BAR CASE # 2016-00396  
2016-00397

City Council  
February 25, 2017

**ISSUE:** Appeal of a decision of the Board of Architectural Review, Old & Historic Alexandria District, approving a Permit to Demolish and Certificate of Appropriateness

**LOCATION:** 319 Queen Street

Figure 1. East (side) elevation of proposed work. Bottom shows area approved by BAR for demolition (solid red) and capsulation (hatched).

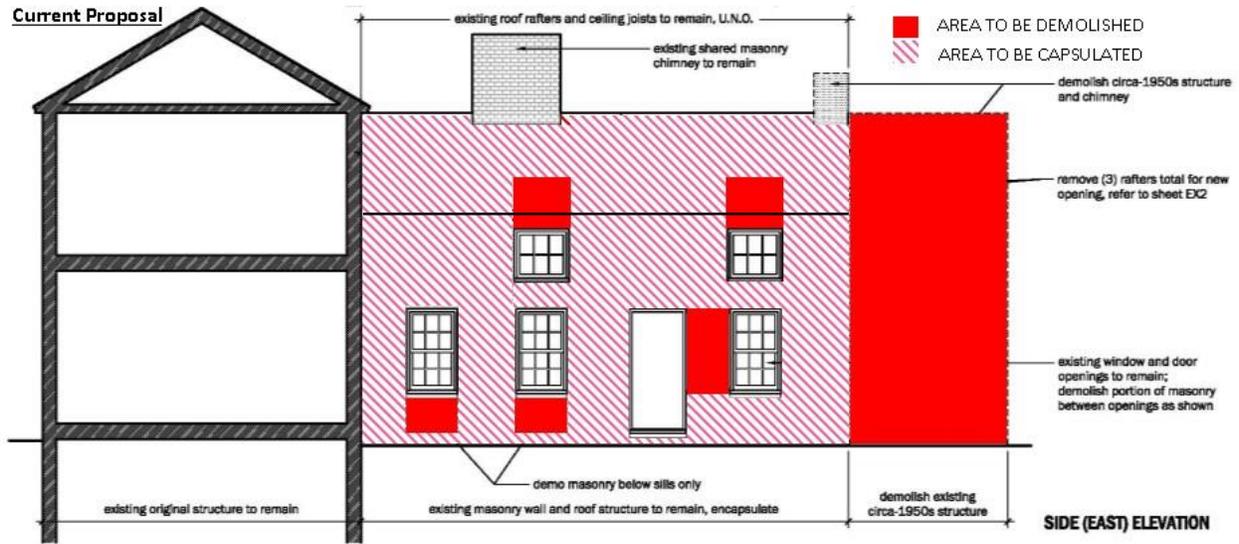
In early conversations with staff, the applicant expressed a desire to demolish the entire rear ell due to the low ceiling height at the second story and staff advised that there would be no support for such a request. Staff was also concerned about the totality of the proposed demolition in the first proposal reviewed by the BAR on December 7, 2016, which proposed to demolish approximately 50% of the roof and wall area, resulting in a significant loss of historic fabric and any understanding of this element as a rear ell.

The applicant's revised proposal, approved by the BAR on December 21, 2016, and currently before City Council on appeal, has significantly limited the amount of demolition. The area proposed for demolition is limited to areas below existing windows (to convert the opening to a door), one small area adjacent to a window opening and demolition of small portions of the existing roof above two existing windows (See Figure 1). The more limited demolition allows the rear ell, both in material and form, to continue to convey its original form, material and craftsmanship and retains its historic integrity. The current proposal to remove only a small part of the roof sheathing and to retain the majority of the brick walls will still permit future historians and architects to be able to study this particular house from the interior. *Staff believes that none of the criteria above apply to the small amount of demolition approved by the BAR.*

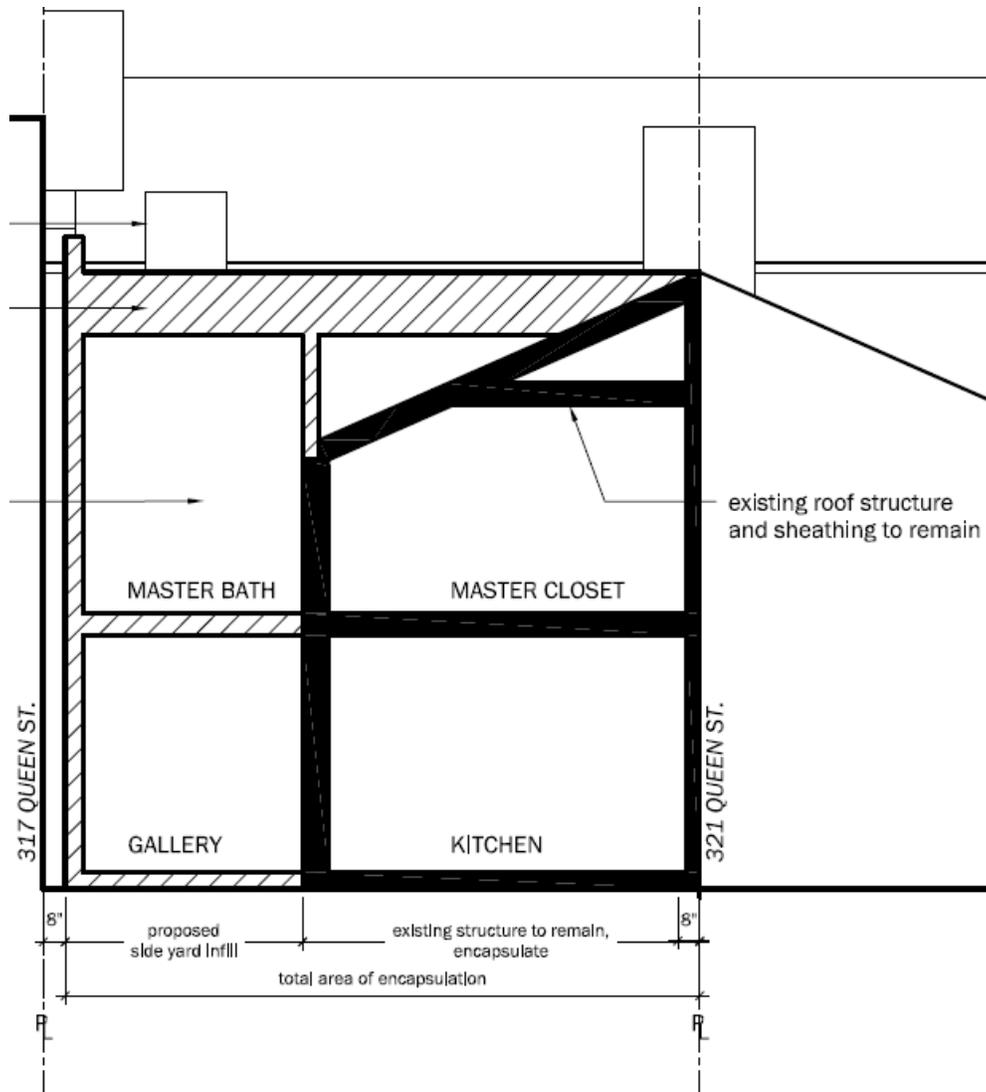
Once an exterior wall is capsulated, it then becomes an interior element and is no longer subject to BAR review. While current owners may agree to retain walls that have been capsulated, unless some form of preservation easement is provided, there is no guarantee that a future owner would not demolish a capsulated wall. The hatched area in Figure 1 shows the area on the east elevation proposed for capsulation, including the brick wall and roof. Therefore, when the BAR has been concerned about the extent of capsulation of a historic wall in the past, the BAR has required that a preservation easement be placed on the area to-be-capsulated in order to ensure that it would be preserved with those materials and in that form once enclosed. At the December 7<sup>th</sup> hearing, several BAR members agreed with staff that demolition criteria 1 & 3 would apply in this case if there was no easement to protect the rear ell in the future, specifically noting that the 1818 rear ell did represent an uncommon design, hand craftsmanship and use of material that would be difficult to reproduce today and that its demolition would be deleterious to the understanding of this building element. There was no consensus among the BAR members for capsulation without a preservation easement on the walls and roof of the ell.

In this case, the applicant met several times in the field with staff and as a result of staff comments made significant changes to their original plan to demolish the entire ell, considerably reducing the extent of demolition. The retention of the majority of the rear ell will allow not just the materials and walls to be retained but also the form and volume will be retained (Figure 2). It is true that the rooms of the rear ell are small by today's standards, which often feature open concept floor plans, but this area has been used for living for almost 200 years and the addition of a hallway in the current side yard will allow furniture to be placed much more efficiently while still preserving the historic volume of the rooms, and therefore the understanding of the evolution of the house over time. Additionally, the applicant agreed to the BAR's condition that a legal instrument be recorded by a qualified preservation organization with respect to the remaining capsulated historic roof framing, decking and the brick walls of the ell and the north wall of the main block of the house in the future. The applicant has begun conversations with the Alexandria Historical Restoration and Preservation Commission regarding donation of an easement on the rear ell.
